UNITED STATES PATENT AND TRADEMARK OFFICE

APPLICATION NO.	FILING DATE	FIRST NAMED INVENTOR	ATTORNEY DOCKET NO.	CONFIRMATION NO.
09/727,839	11/30/2000	Ashok Machcha	Q00-1017-US1	3918

## Office Action Summary

**Mihara et al Fig. 5, annotated detail**

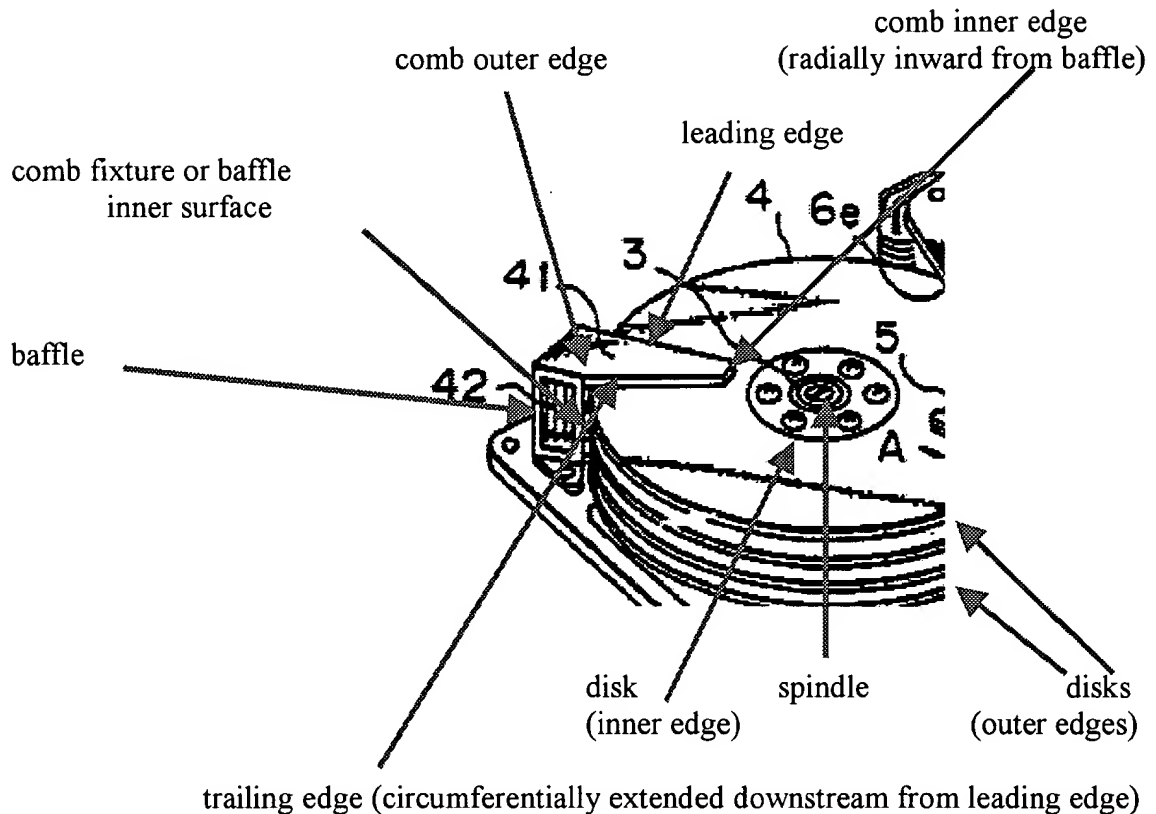
As recited in claim 1, Mihara et al show a disk drive assembly comprising: a spindle 3 adapted to rotate about a longitudinal axis (out of page in Fig. 1, vertical in Fig. 5); data storage disks 4 surrounded by fluid medium (air), each of the disks 4 having a disk outer edge and a disk inner edge, the disks being mounted on the spindle 3 to rotate therewith about the spindle longitudinal axis, rotation of the disks in a first direction creating a flow of the fluid medium in the first direction R, at least one of the disks having approximately concentric tracks ("a desired track", see col. 1, line 63) disposed at different radial positions between the disk outer edge and the disk inner edge; slider assemblies (including 8), each slider assembly including at least one transducer 5 head capable of reading and writing information on one of the disks; an actuator assembly 6 for positioning the slider assemblies over the tracks; a baffle (see Fig. 5, annotated detail) disposed upstream of the actuator assembly, the baffle (in which 42 is located) extending in a direction of the spindle longitudinal axis (vertically in Fig. 5) and having an inner surface disposed outside of the outer edges of the disks; and combs 41 mounted on the baffle, at least one of the combs disposed adjacent to at least one of the disks 4 to form a gap (between 4 and 41) between the comb 41 and a corresponding adjacent disk 4, the gap disposed in the direction of the spindle longitudinal axis; extends radially inward from a comb outer edge to a comb inner edge, a portion of the comb outer edge disposed at the inner surface of the baffle; disposed upstream (see Fig. 1, in which 41 is upstream of 8 in an R direction) of a corresponding actuator assembly (including 8); extending in a disk circumferential direction from a leading edge to a trailing edge, the leading edge disposed upstream (see R direction in Fig. 1; see also ) of the trailing edge; and extending radially inward from the baffle.

fixture (including 42) disposed apart from the actuator assembly 6, and having an inner surface separated by a first distance from the outer edges of the disks 4; combs 41 coupled with and extending inwardly from the comb fixture, at least one of the combs 41: disposed adjacent to a corresponding adjacent disk 4 to provide a gap between the comb 41 and the corresponding adjacent disk 4, the gap disposed in the direction of the spindle longitudinal axis; and extending circumferentially (see Fig. 5 annotated detail) around the spindle longitudinal axis.

As recited in claim 19, Mihara et al show a comb assembly for reducing cross-track motion in a disk drive, the disk drive including at least one disks 4, a spindle 3, and at least one slider assembly (including 8), the comb assembly comprising: at least one baffle (in which 42 is located) disposed upstream of the slider assemblies, the baffle having an inner surface (see Fig. 5 annotated detail) disposed outside of outer edges of the disks 1; and at least one comb 41 mounted on the baffle, wherein each comb 41: is disposed adjacent to at least one of the disks 4 to provide a gap between the comb 41 and a corresponding adjacent disk 4, the gap disposed in the direction of a spindle longitudinal axis; extends radially inward from a comb outer diameter (see comb outer edge in Fig. 5 annotated detail), the comb outer diameter disposed approximately at the inner surface of the baffle; disposed upstream (see R direction in Fig. 1) of the slider assemblies (including 8); extending in a disk circumferential direction from a leading edge to a trailing edge, the leading edge disposed upstream of the trailing edge; and extending radially inward from the baffle (see Fig. 5 annotated detail).

As recited in claim 2, Mihara et al show that the baffle comprises a baffle plate (see Fig. 5, which clearly shows filter 42 surrounded by 4 baffle plates).

As recited in claim 3, Mihara et al show that the baffle plate (4 baffle plates surround 42) and the combs 41 are elements of an integral mechanical structure (see Fig. 5).

As recited in claim 4, Mihara et al show a second set of combs (arbitrarily choose one of the four combs 4; the remaining combs constitute a second set of combs) extending radially inward from an outer attachment element inner surface (see baffle inner surface in Fig. 5 annotated detail), the outer attachment element inner surface having a diameter not less than the outer edge of the disks 4, each of the second set of combs: disposed in a position adjacent at least one of the disks 4 in the direction of the spindle 3 longitudinal axis ("A baffle plate 41 is disposed corresponding to each of the four magnetic discs 4 facing the upper surface thereof", see col. 4, lines 41-43); and disposed downstream (please note that each comb 41 is located simultaneously upstream and downstream of the slider assemblies, due to the cyclical nature of the disk rotation and airflow) of the slider assemblies (including 8).
